Subject: Class II permissive change Request

FCC ID: 2AZ9X-HBMFX

Granted on: 07/29/2021

Comparison between the old and new photos and circle the differences

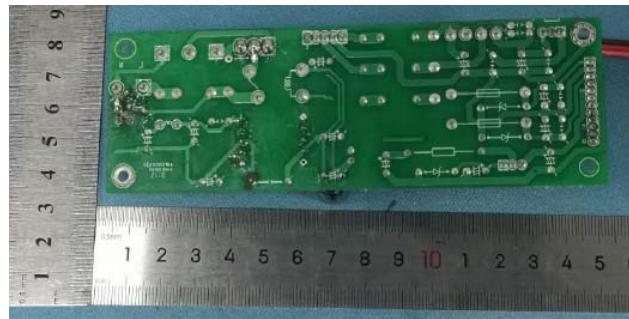
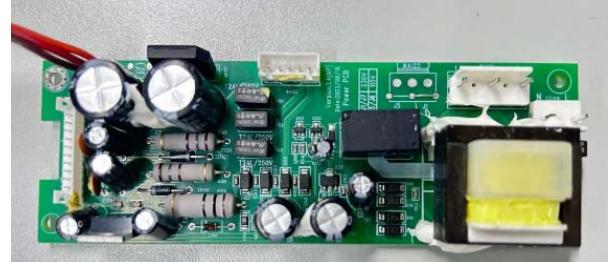
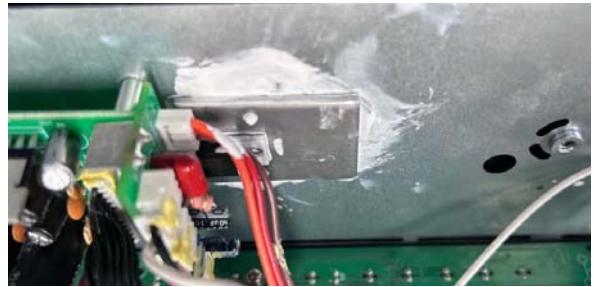
1. The small power supply board (auxiliary power supply) is changed to a linear transformer, and the main power transformer is unchanged;
2. The three glass tube fuses on the small power supply board are changed to box fuses;
3. Changes in the installation mode of the power amplifier IC (will affect the overall temperature rise).
